Waveform④ Before change

Waveform⑤ After change

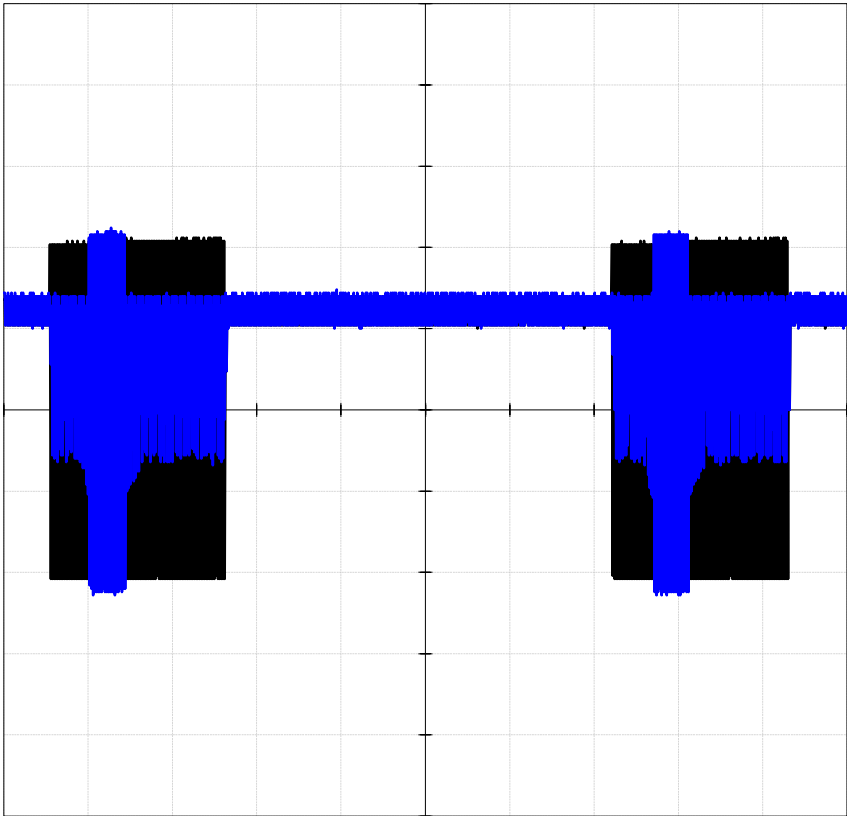
Input : 230 V
Output : 0 V
0 A

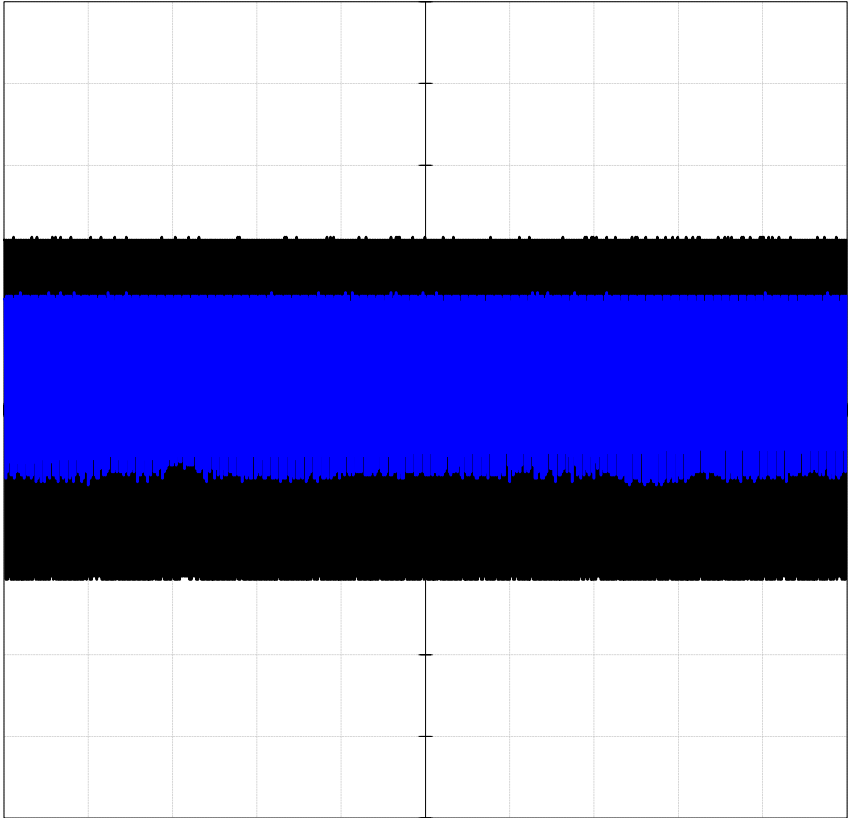
Input : 230 V
Output : 0 V
0 A
